PROPOSED PLUGGED WELLBORE SKETCH Apache Corporation

Apache Corporation NMLC067832C; West Indian Basin Unit #5 680' FNL & 1690' FEL Section 20, T.21 S., R.23 E. Eddy County, New Mexico

RE: Plugging and Abandonment Requirements, Conditions of Approval

CURRENT WELLBORE SKETCH Apache Corporation

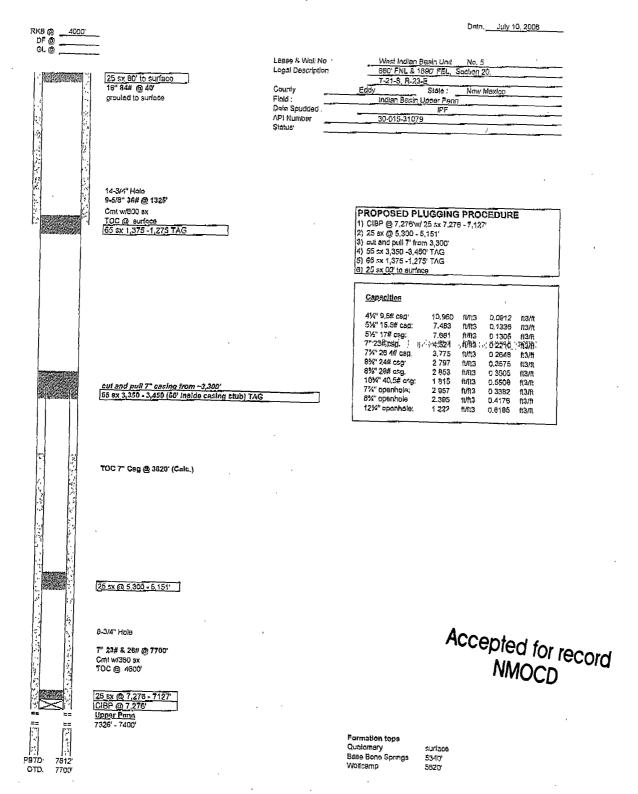
- 1. OK as is.
- 2. Spot a balanced plug from 7019'- 6605' (covers the Wolfcamp and Penn tops).
- 3. Spot a balanced plug from 3935'- 3795' (covers the Bone Spring top).
- 4. Cut and pull 7" from 3300'.
- 5. Spot a balanced plug from 3350'- 3320' (stub plug). WOC and tag no lower than 3320'.
- 6. Spot a balanced plug from 1375'- 1275' (9-5/8" shoe). WOC and tag·no lower than 1275'.
- 7. Spot surface plug from 150' to surface.
